START_DETECT fix for D2.3 v100

This baseline addresses an issue specific to the START_DETECT state and how 'function_done' is evaluated.

145.2.5.7 State diagrams

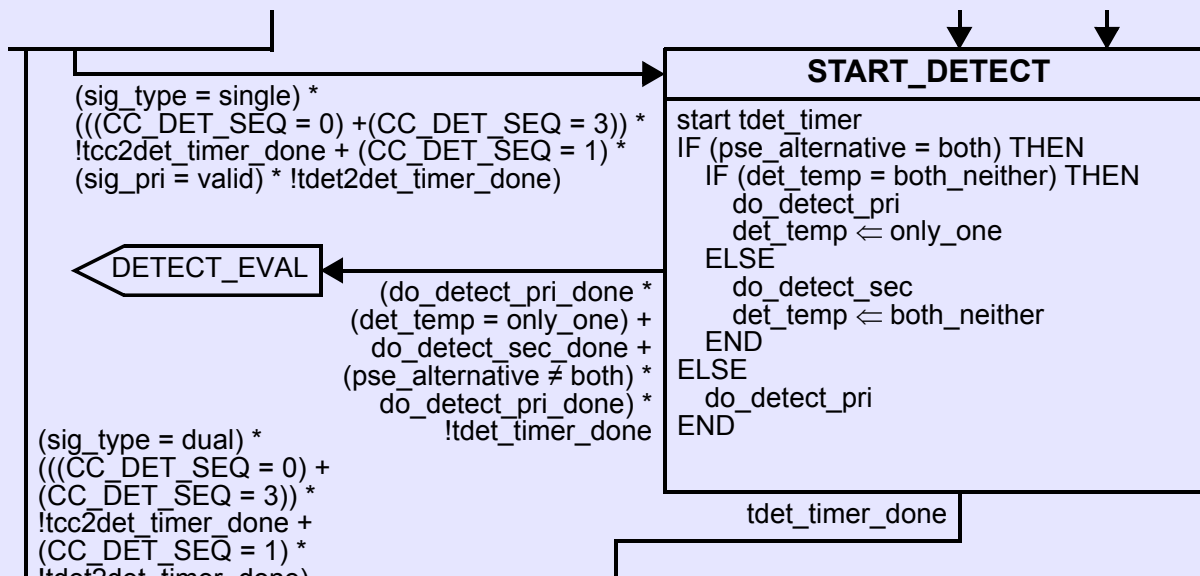
The arc from START_DETECT to DETECT_EVAL checks both **do_detect_pri_done** and **do_detect_sec_done**. Only one of the corresponding functions will have been called by the START_DETECT state, depending on the value of pse_alternative and det_temp.

What is the value of the do_detect_(pri|sec)_done, which hasn't been called ?

- If this is the first round through START_DETECT, the function has never been called. While not 100% clear cut per our current state diagram rules, the function would be considered "done". Even if we were to adopt text that said "Functions that have never been called evaluate as not done", this would not solve the issue, see next item.
- If the state diagram has had a prior run through START_DETECT and called the function, it would still be considered "done", even though it hasn't been called this time around.

Regardless of interpretation of the rules, this doesn't work.

Solution: we need to avoid checking the 'doneness' of a function that hasn't been called. Only START_DETECT has this issue.

Replace the arc logic from START_DETECT to DETECT_EVAL as follows:

!tdet_timer_done * (
(do_detect_pri_done * ((det_temp = only_one) + (pse_alternative ≠ both))) +
(do_detect_sec_done * (pse_alternative = both) * (det_temp = both_neither))
)
